Revolution Wind Farm and Revolution Export Cable – Offshore Wind Energy Project

Essential Fish Habitat Assessment—Addendum

March 20, 2023

Table 1. BOEM responses to NMFS comments and requests for additional information on the Revolution Wind EFH Assessment.

Figure B-1. Approximate extent of underwater noise from impact pile driving for Revolution Wind foundation installation exceeding thresholds for injury and behavioral effects on fish and invertebrates.

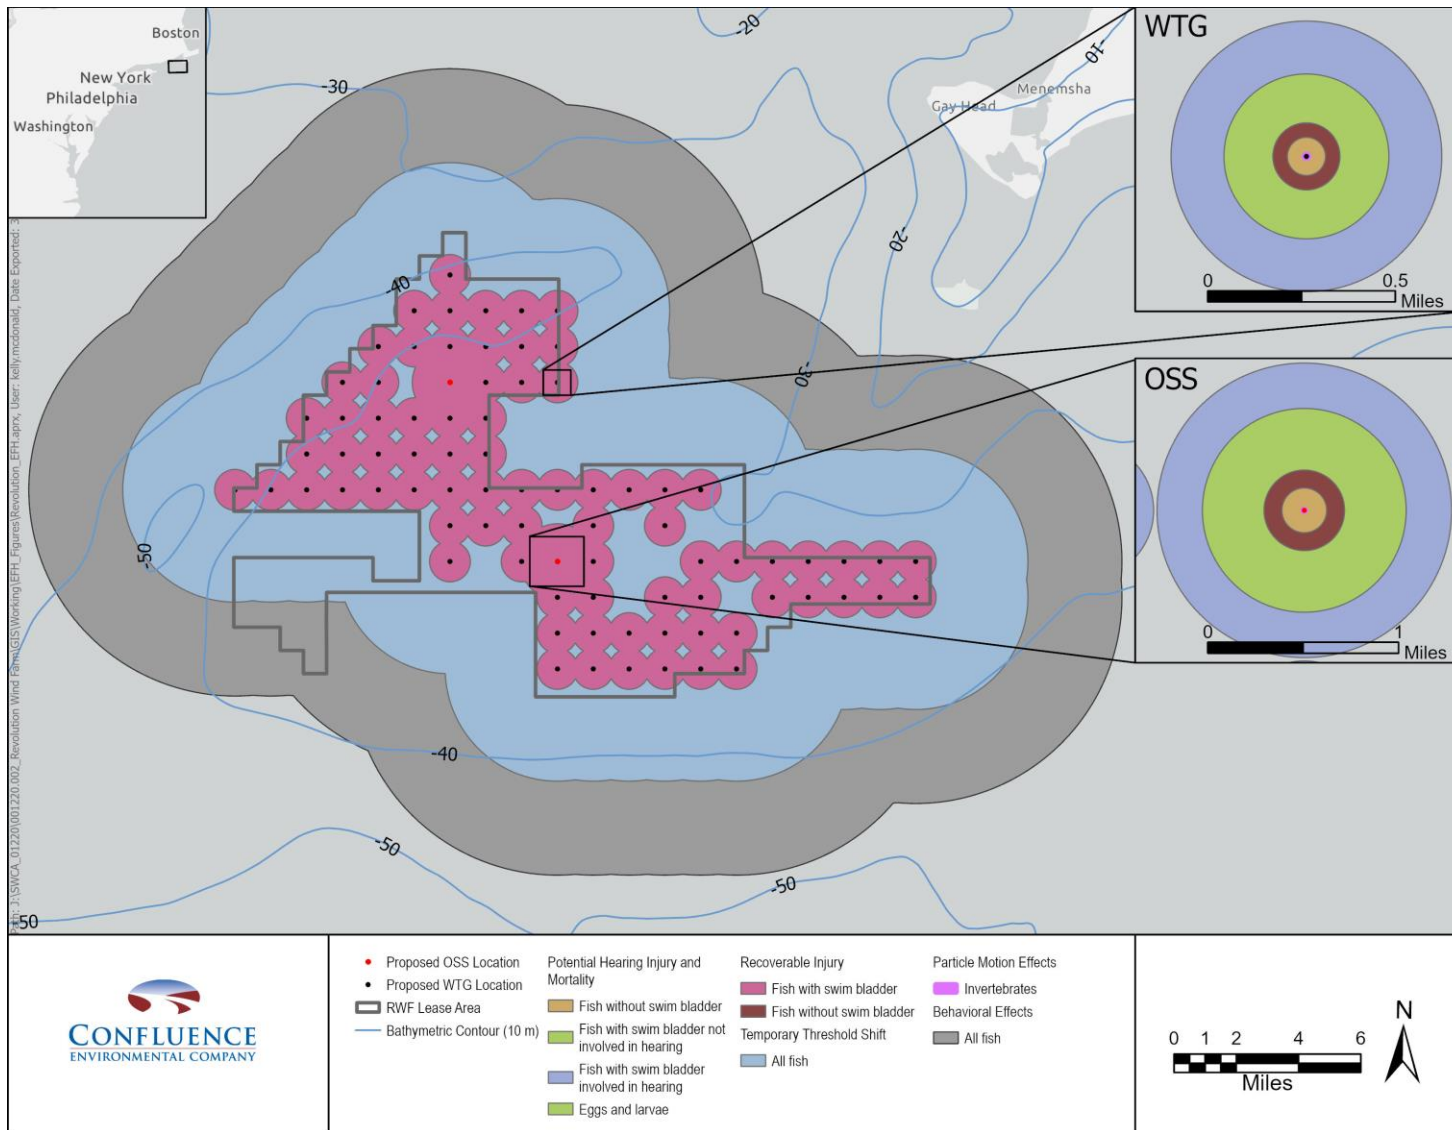
11	Pile Driving Activities	We appreciate the additional information that was provided related to pile driving activities. However, some of the information requested in our June 2022 letter has not been incorporated. Specific to the proposed action, please provide information related to the extent of acoustic impacts within and outside the project area (a map or graphic would be helpful). Additionally, please provide information on proposed plans for adaptive monitoring to ensure target attenuation levels are met.	The EFH Assessment submitted to NMFS includes the requested figure and supporting analysis: Figure 5.1 displays the approximate maximum extent of potential sound impacts on EFH species from impact pile driving, and Table 5.4 presents the range of modeled threshold distances for pile driving-related noise producing activities by EFH species hearing group. A review of current literature and supporting analysis of sound pressure and particle motion effects is provided in Section 5.1.1.4. EFH Assessment Figure 5.1 displays both SPL and currently quantifiable particle motion effects for invertebrates. Insufficient information is available to estimate threshold distances for particle motion effects on fish, particularly those associated with seabed vibration, which is substrate dependent. Therefore, these effects cannot be usefully represented on the figures provided.

Comment/ Request #	NMFS Topic/General Request	NMFS Comment/Specific Request	BOEM Response
			<p>An updated version of Figure 5.1 and a companion figure displaying the extent of potential noise impacts from pile driving methods that may be used at the sea-to-shore transition site are provided in Attachment B. The updates include the bathymetric contours requested in NMFS June 24, 2022, comment letter. NMFS also requested that benthic habitat types be displayed on the same figures. BOEM feels that this would not be practicable or useful for the following reasons:</p> <ol style="list-style-type: none"> 1. The generalized impact areas for some noise effects extend beyond the areas surveyed by Inspire Environmental (2023); therefore, the distribution of habitat types in these areas is not known. 2. The impact area features shown are generalized representations of the potential extent of noise impacts, not accurate depictions (see Attachment B for additional discussion). Therefore, attempting to interpret habitat exposure to noise effects from these features could result in conclusions based on false precision. 3. Displaying benthic habitat types would compromise overall legibility and the ability to discern certain noise impact features from the background habitat layer. <p>The distribution of habitat types within the RWF and RWEC corridor and the location of noise generating project features are provided in the EFH Assessment in Figures 3.3 and 3.4. In addition, the EFH Assessment was revised to include detailed habitat type mapping by zone in response to prior NMFS information requests. Please see Section 3.5 in the EFH Assessment for the associated maps and habitat descriptions.</p> <p>A sound field verification plan was provided as Attachment 7 in the Protected Species Mitigation and Monitoring Plan (PSMMP; COP Appendix Z; https://www.boem.gov/renewable-energy/state-activities/appz3-revpsmmp). This noise measurement plan for sound field verification (SFV) is proposed in connection with the planned foundation installation activities for Revolution Wind. At least 90 days prior to planned start of pile driving, a sound field verification plan will be submitted to NMFS by the lessee for review and approval.</p>

This attachment presents BOEM’s response to NMFS comment/information request #11 for the EFH Assessment (see Table 1 in main body of the addendum). NMFS has requested a figure displaying the extent of acoustic impacts from impact pile driving used for installation of wind turbine generator and offshore substation foundation monopiles. The requested figure for the RWF was provided in the EFH Assessment as Figure 5.1. BOEM is providing an updated version of this figure, now including bathymetric contours, and a companion figure for pneumatic and vibratory pile driving proposed for construction of the RWEC sea-to-shore transition. These are presented below as Figures B-1 and B-2, respectively.
